S-TYPE

S307-03

TECHNICAL BULLETIN

DTC P0741 –
Torque Converter Clutch Does Not Lock Up –
Missing Seal Ring

LOCATION OF OIL SEAL ON STATOR SHAFT

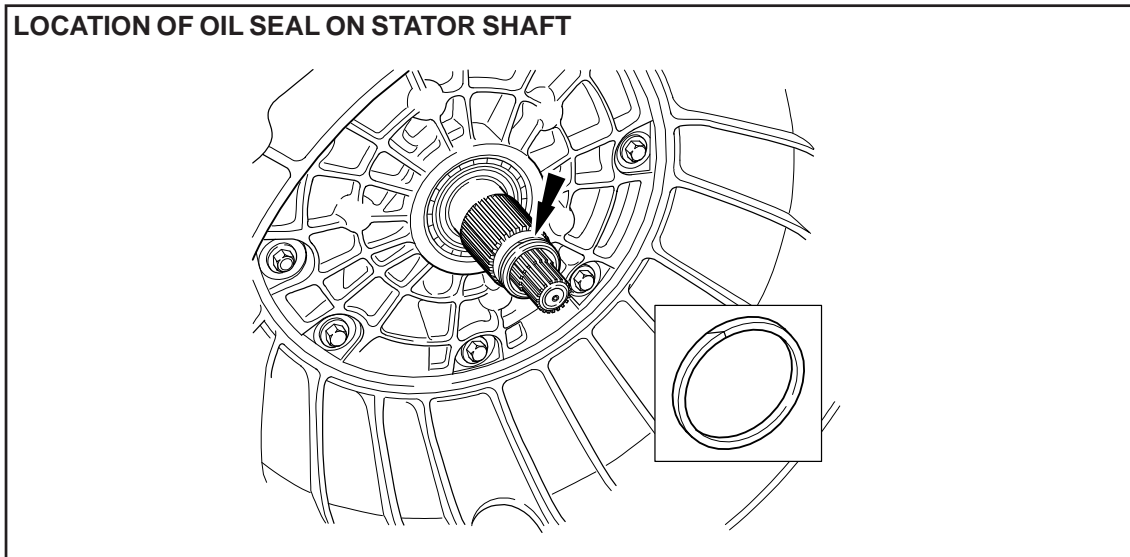
3. Inspect the stator shaft and determine if the seal is damaged or if no seal is present at the location shown in illustration 1.

4. If no transmission input shaft seal is installed, install a new seal.
5. Install the transmission torque converter.
6. Install the automatic transmission (see Global Technical Reference GTR Workshop Manual, section: 307-01, SRO 44.20.01).
7. Use WDS to carry out a transmission fluid level check (see Global Technical Reference GTR Workshop Manual, section: 307-01, General Procedures).
8. With WDS already connected, clear all DTCs from the Transmission Control Module (TCM).
